Proposed Text for Section 3, Based on responses to Draft D1 Letter Ballot processed at March 1995 Meeting

Abstract: This paper presents the changes to section 3 in the Draft Standard P802.11/D1 as a result of the Response to Draft D1 Letter Ballot processed at the March 1995 Meeting as shown in the companion Document P802.11-95/64. Not all Letter Ballot comments were processed at the March 1995 Meeting.

Action: Adopt the changes in this paper to replace the relevant portions of Section 3 of P802.11/D1.

Figure 3-3: Example of SDE Transmission Procedure

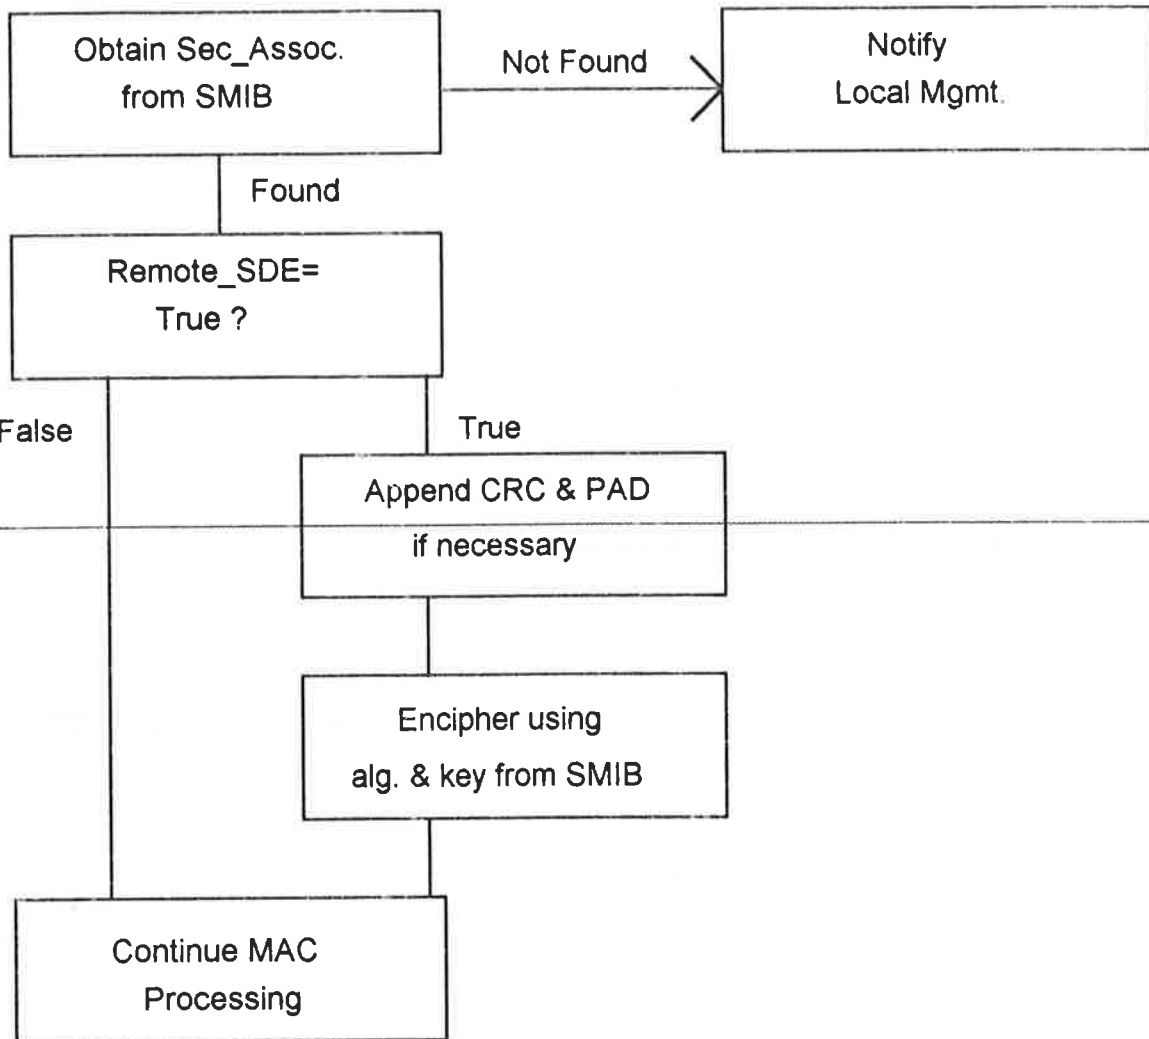
~~Transmission procedures...The transmission procedures are those involved in processing an UNITDATA request. The functions are represented as a flow chart shown below, (Object values are contained in the SMIB):~~

In response to an UNITDATA request from the LLC sub-layer, the supplied address parameters are used to search for a security association in the SMIB:

- 1).....If the search is successful, the data is processed or passed unprocessed if the SMIB indicates that Remote_SDE = False.
- 2).....If no security association is found, the local management entity is notified. This may initiate the association procedure.
